SERVICE

X 95.006-26

Model 3120

Flywheel

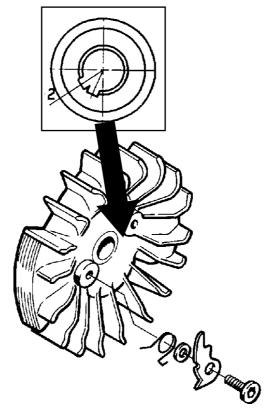
An ignition system with a lower speed is fitted to the engine unit used on the Railtech fixture. This system requires another ignition timing setting. The flywheel has therefore be equipped with double keyways.

The keyway marked "2" is used on engine units used on Railtech.

The unmarked keyway is used on chain saws.
